ADDENDUM NO. 1

RE: Item #4, January 22, 2025 Letting - NH 0083(88)40, PCN 074F, Mellette County - Replace Pipe & Drainage Improvements

STATE OF SOUTH DAKOTA	PROJECT NH 0083(88)40	SHEET 24	TOTAL SHEETS 45
-----------------------	--------------------------	-------------	--------------------

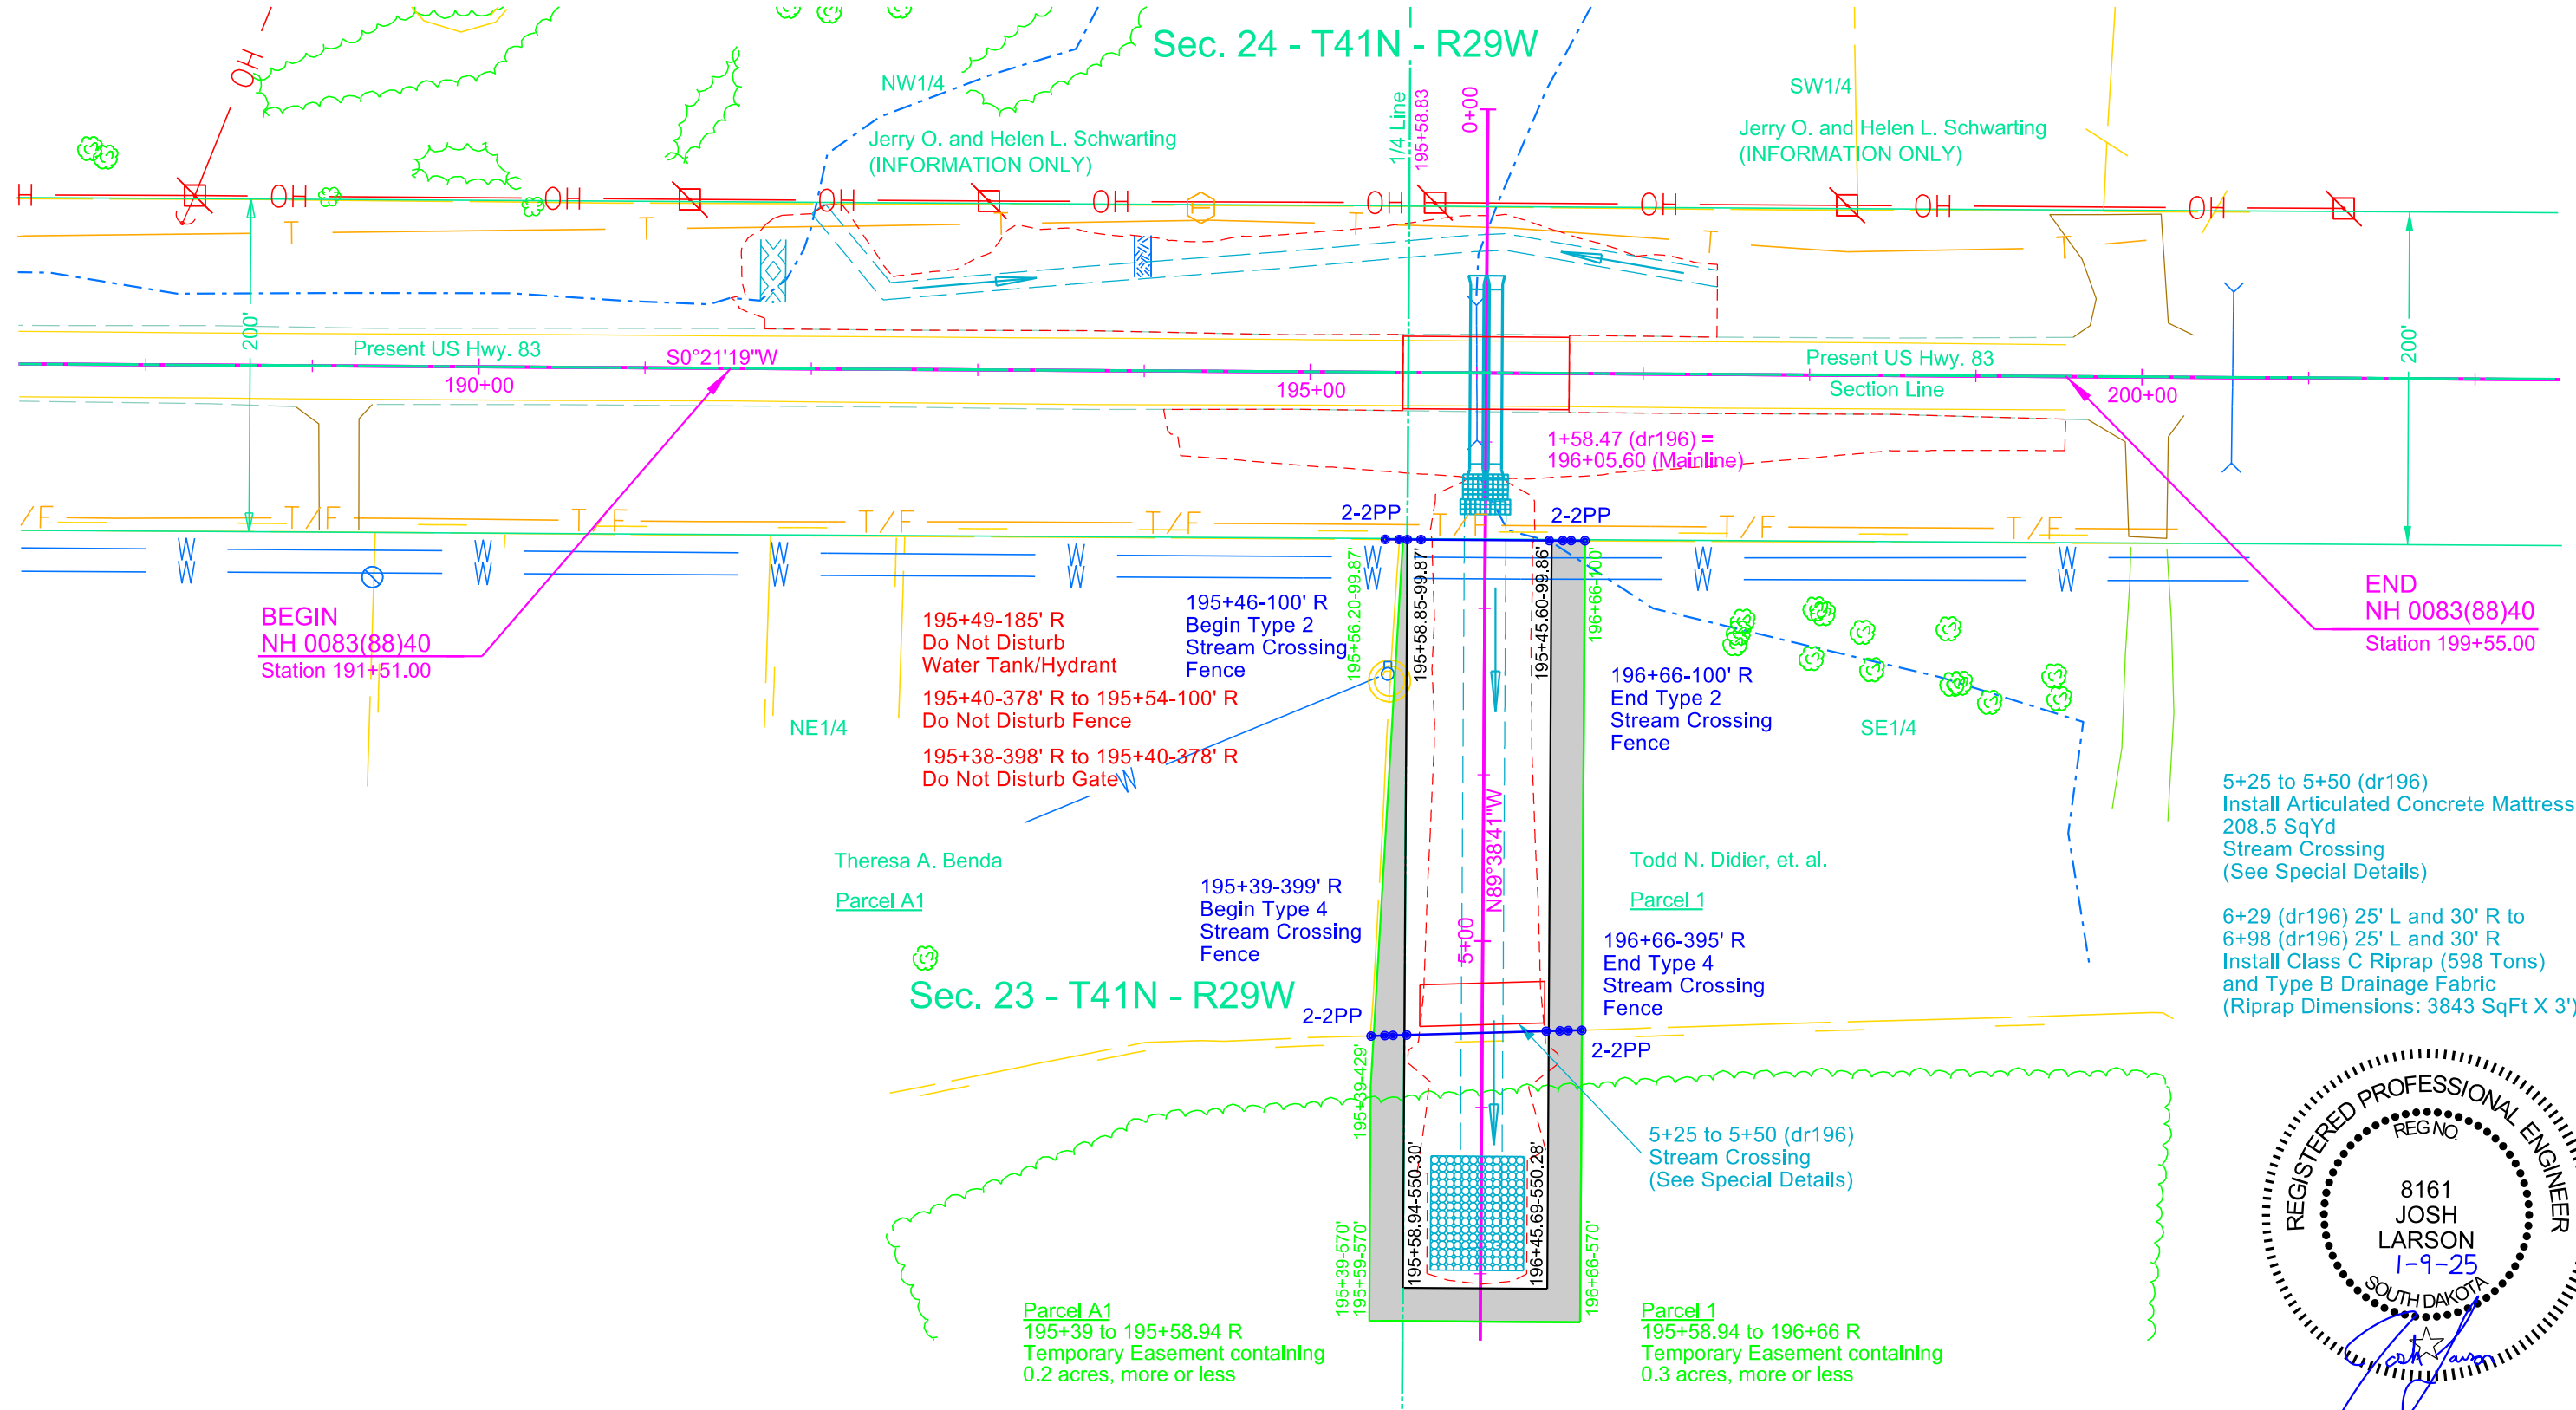
Sheet 24: Revised Note for Twin Pipe Outlet Bank and Channel Protection Gabions to Twin Outlet PVC Coated Bank and Channel Protection Gabions and Revised Note for "6+29 (dr196) Install Class C Riprap" to "6+29 (dr196) 25' L and 30' R to 6+98 (dr196) 25' L and 30' R Install Class C Riprap.

196+06 R
Install Twin Pipe Outlet PVC Coated
Bank and Channel Protection
Gabions (21.5 CuYd) and Type B
Drainage Fabric (57 SqYd)

6+29 (dr196) 25' L and 30' R to
6+98 (dr196) 25' L and 30' R
Install Class C Riprap (598 Tons)
and Type B Drainage Fabric
(Riprap Dimensions: 3843 SqFt X 3')
